STATE OF NORTH CAROLINA
DEPARTMENT OF TRANSPORTATION

Addendum No. 1
RE: Contract # C204039
WBS # 34243.3.2
STATE FUNDED
Polk County (I-4729A)
I-26/US-74/NC-108 Interchange Modifications in the Town Of Columbus

September 19, 2017 Letting

The following revisions have been made to the Roadway plans:

17-AUG-2017 10:15
J:\1-4729A\Roadway\XSC\I-4729A_Rdy_xpl.dgn
$$$$USERNAME$$$$

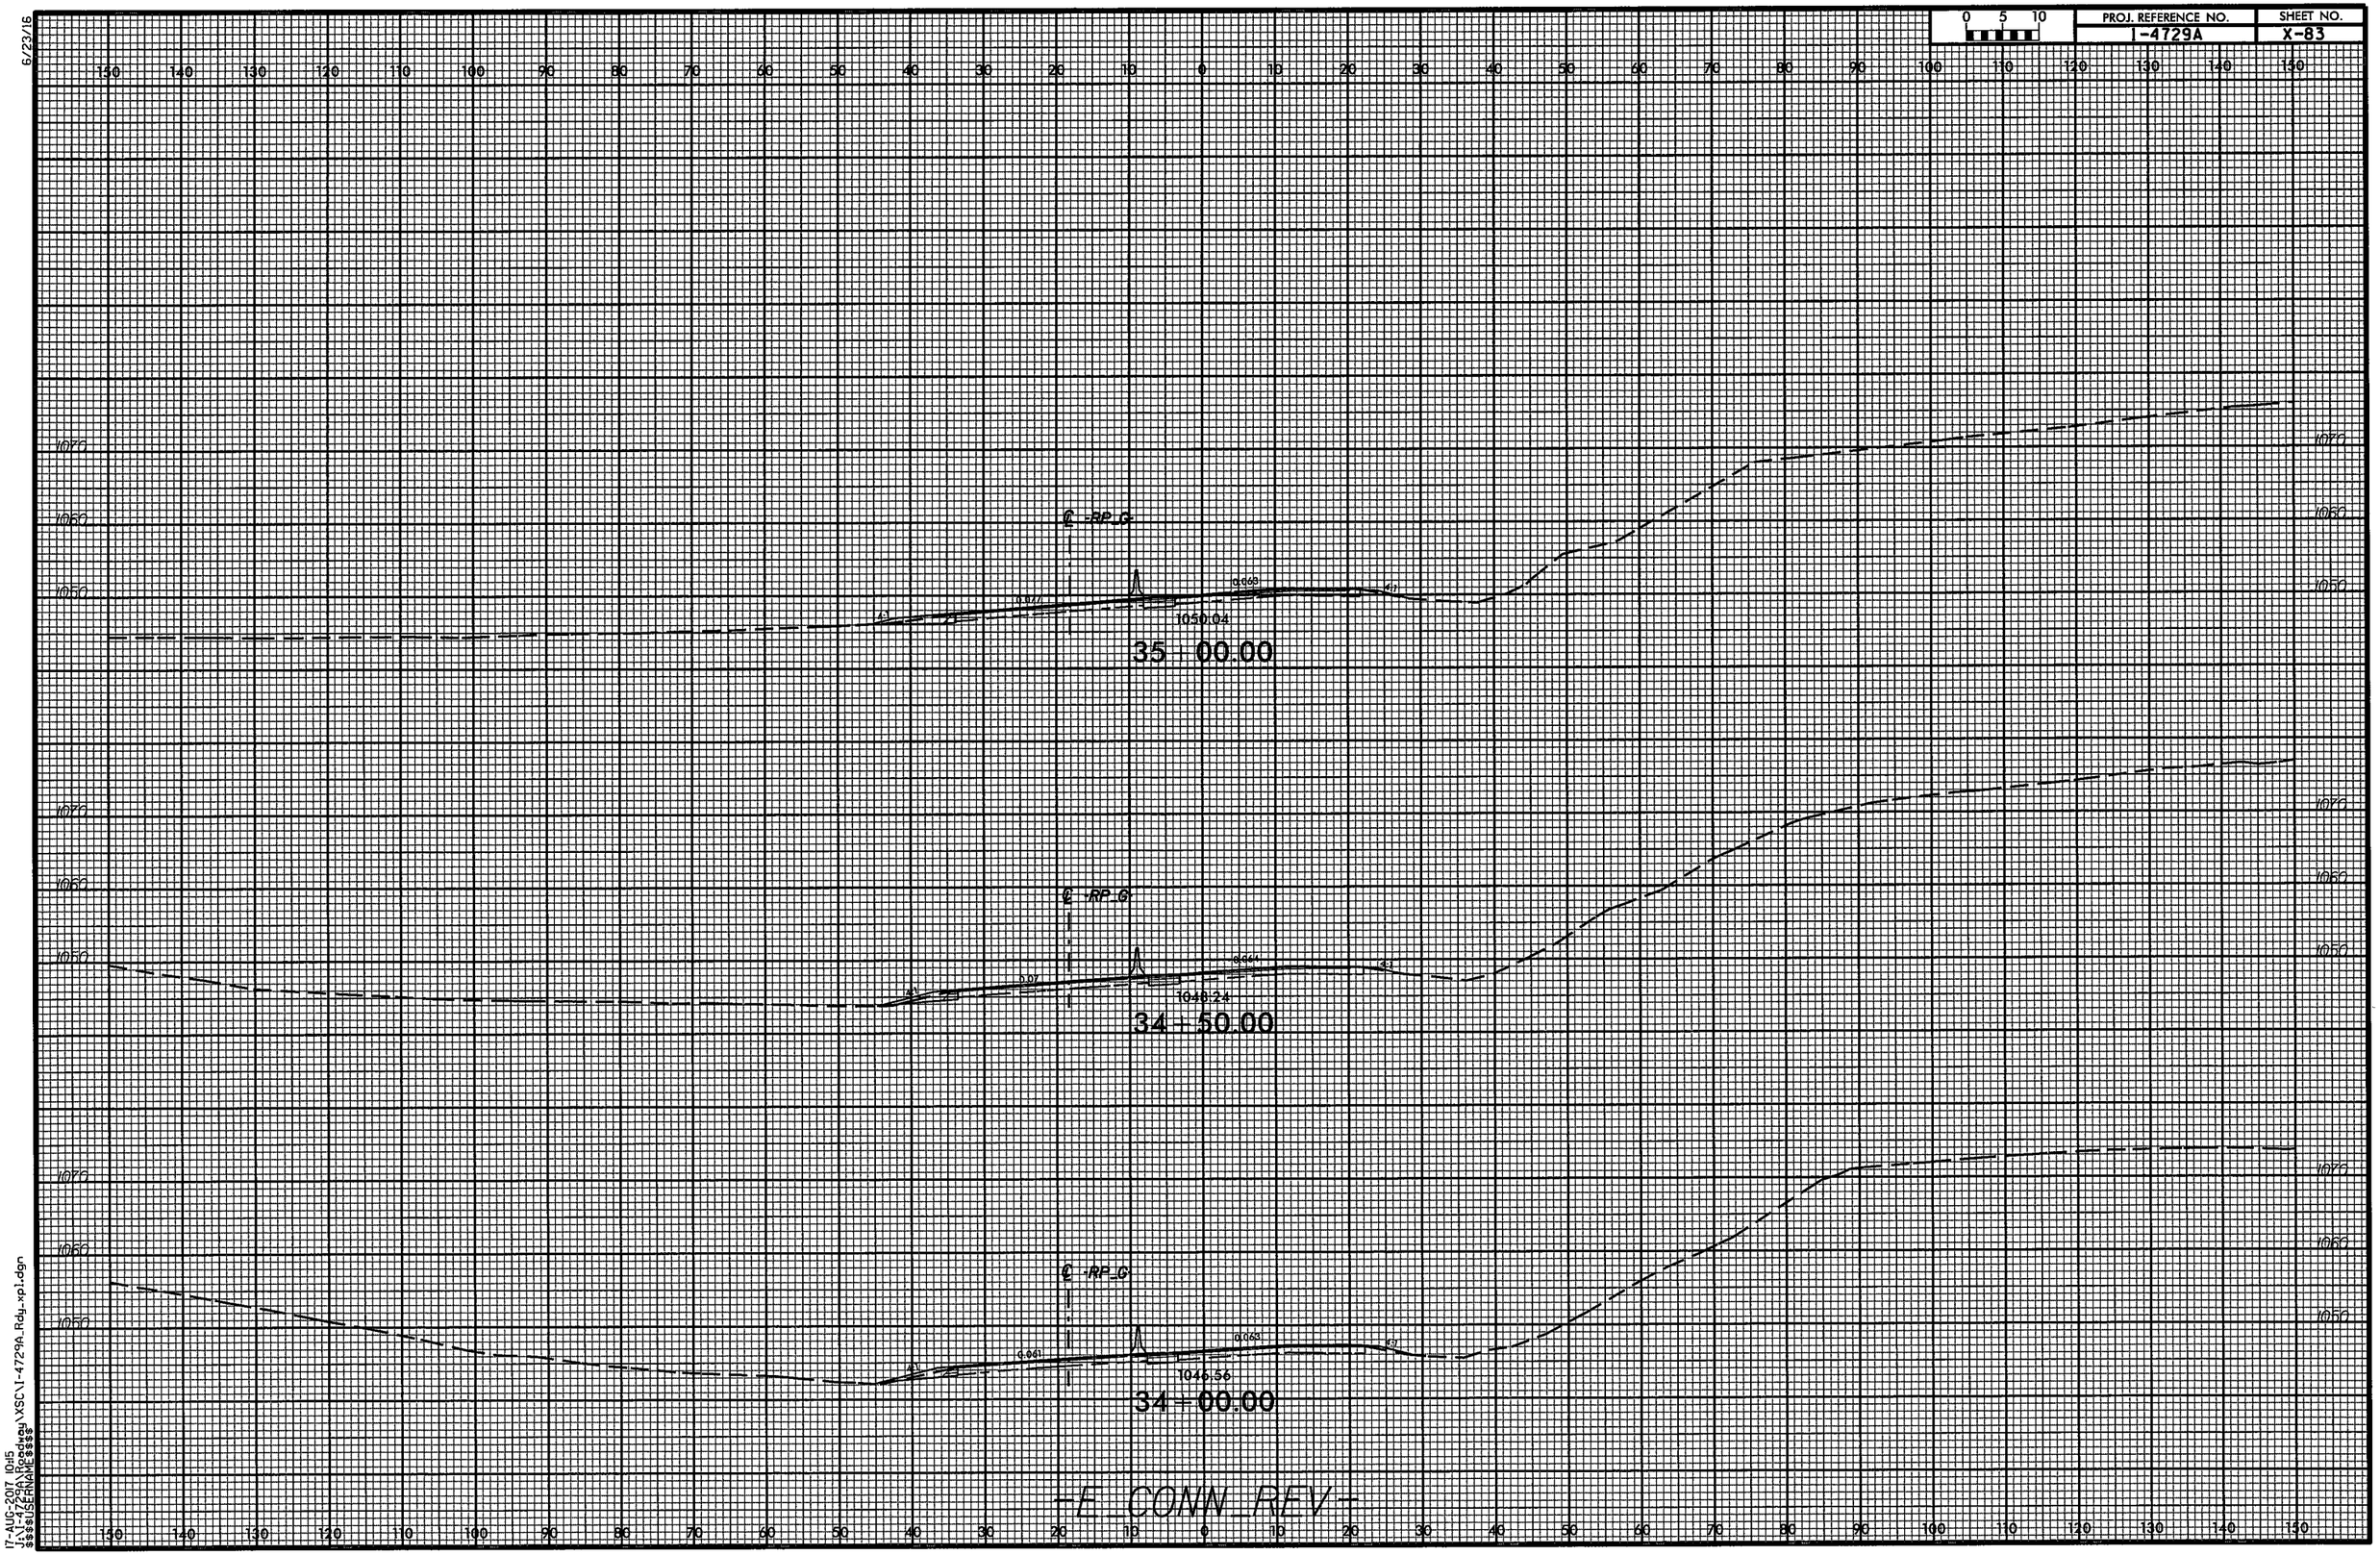
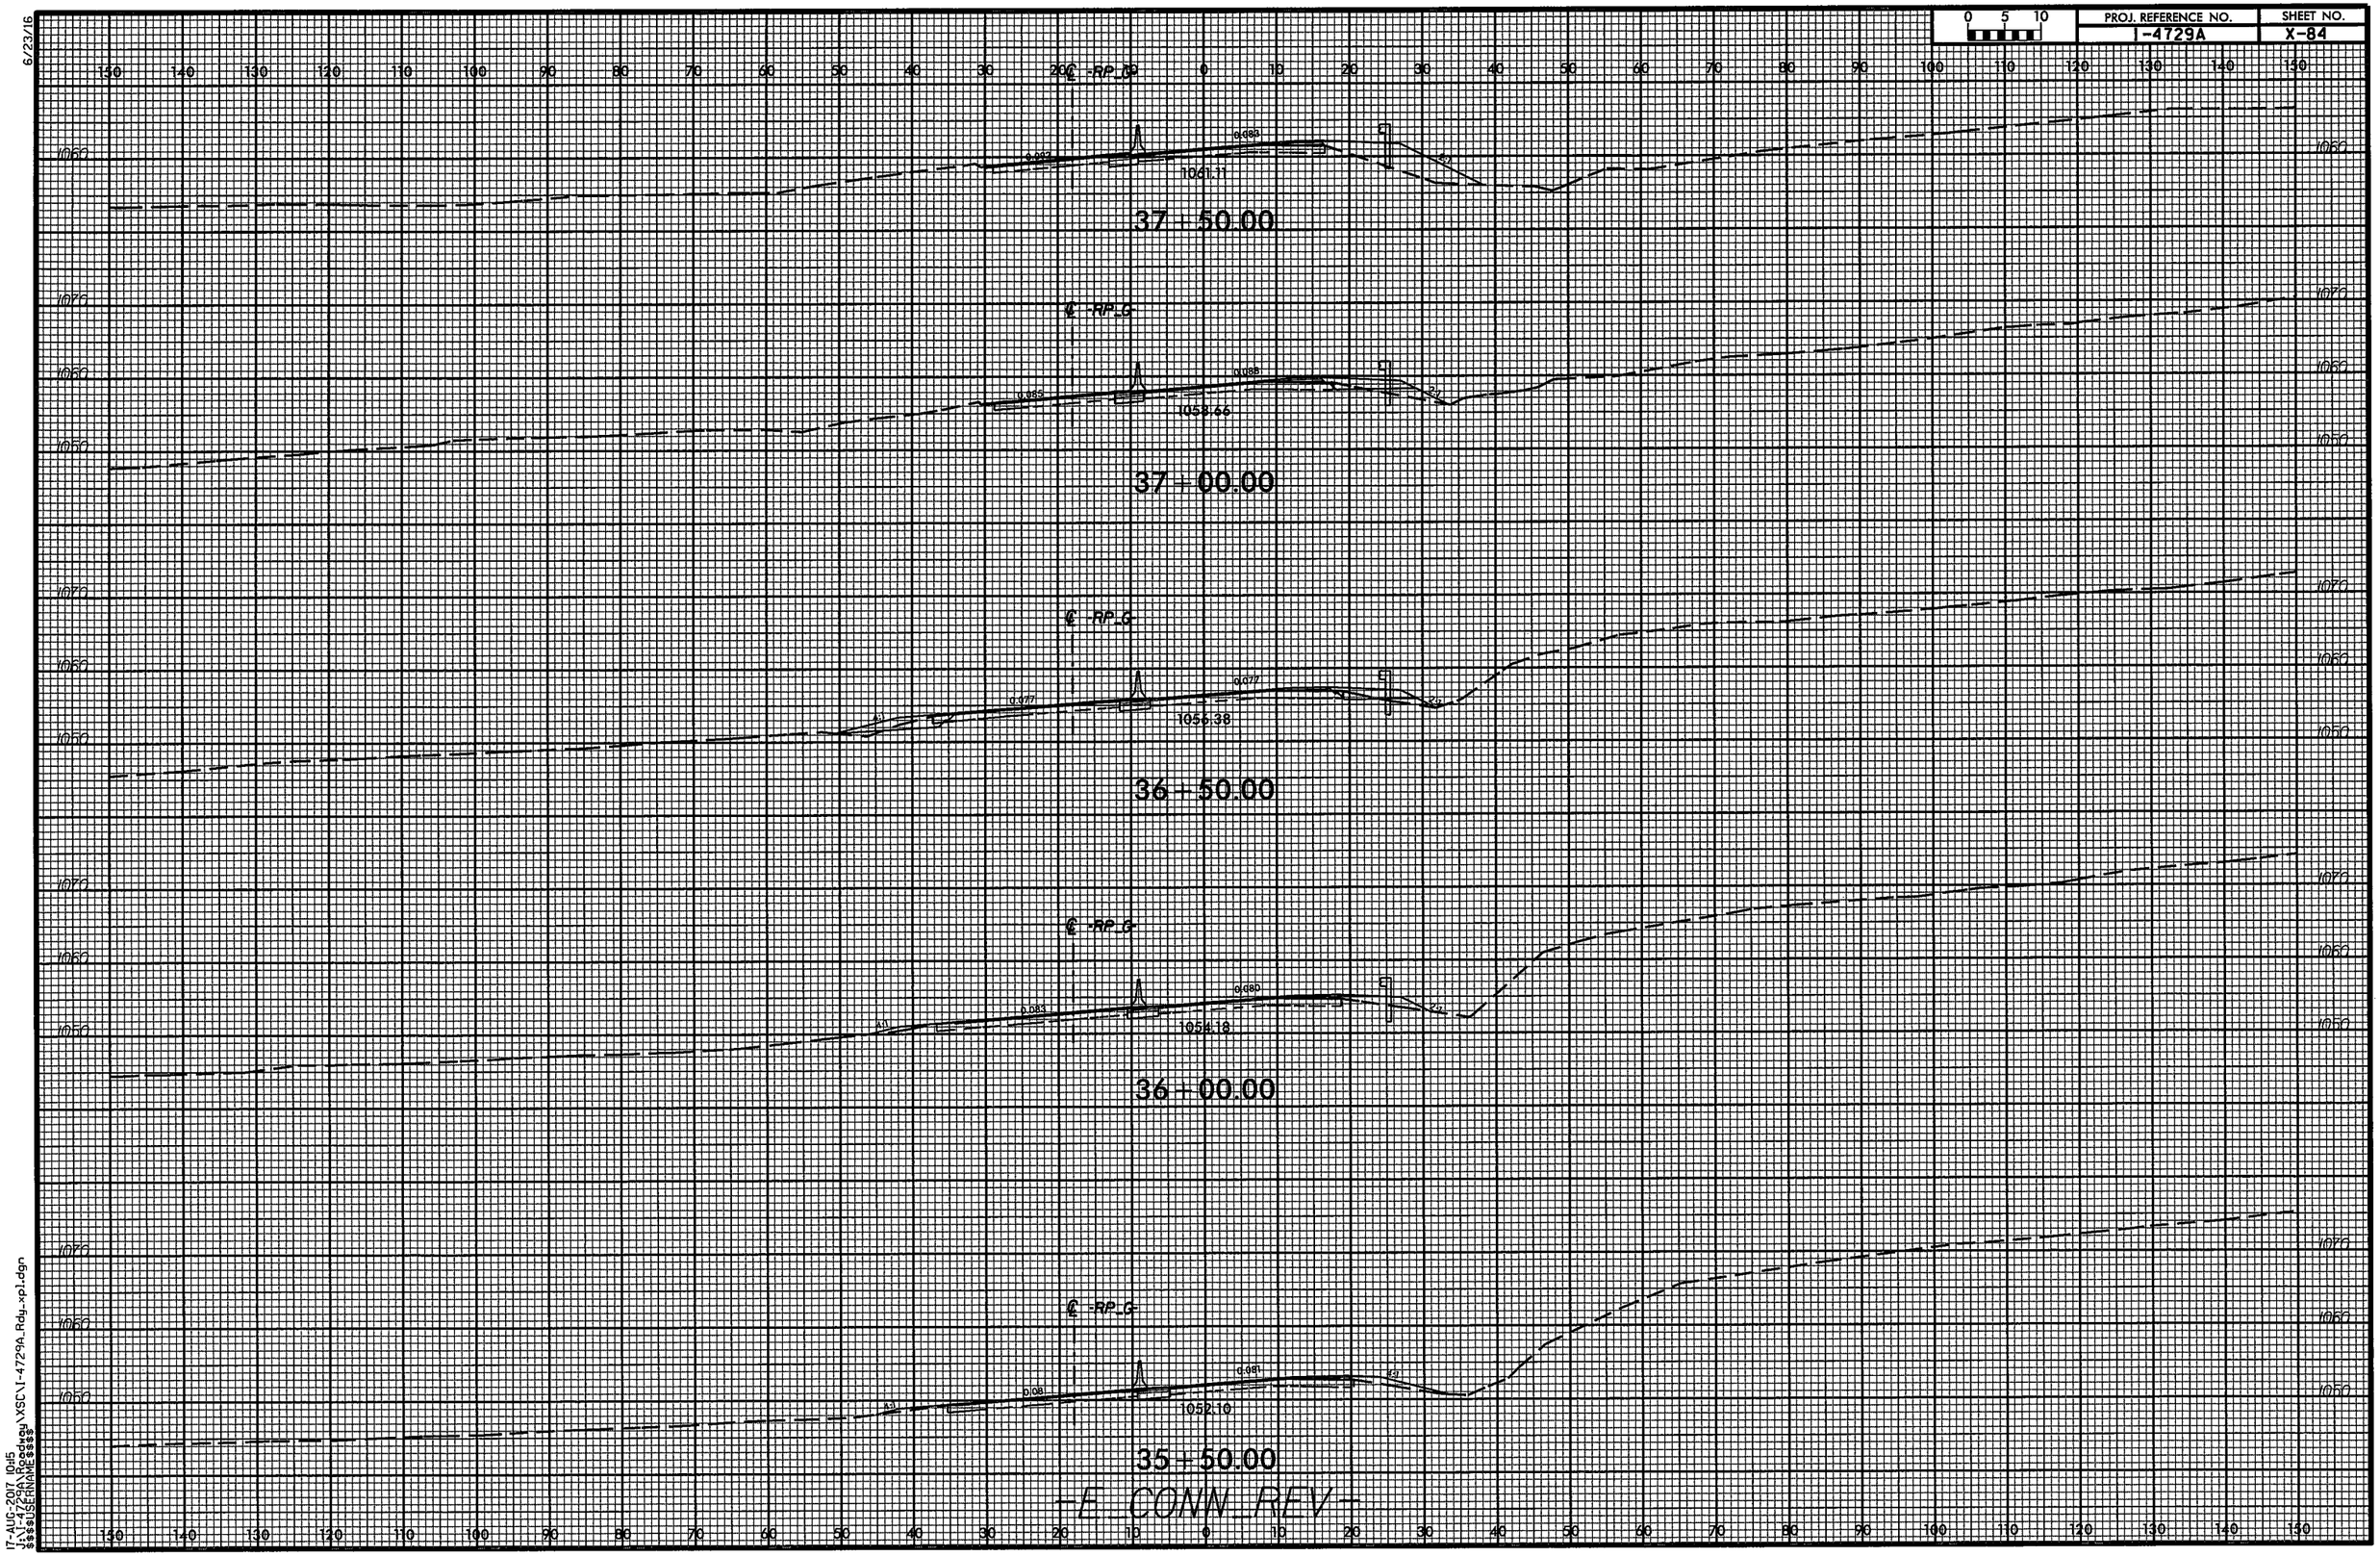
Sheet No.	Revisions
1A	Revised Index of Sheets to remove 2G-2 "Standard Embankment Monitoring Detail" and revise the number of" Drainage Summaries" sheets
2A-1, 2A-4 and 2A-5	Revised the Typical Sections for the change in mainline pavement widening design from ABC to Asphalt Base
3B-1	Revised 'Summary of Earthwork' to account for pavement widening design change
3D-1 thru 3D-4	Various drainage quantity changes as noted below
3G-1	Removed "Settlement Gauge Summary" and added note that Bridge Waiting Period only applies to Approach Slab construction
5	Revised to require Welded Steel Pipe by Trenchless method under the Interstate 26
X-1A thru X-87	Revised Cross-Sections to reflect the change in Earthwork due to the pavement design change
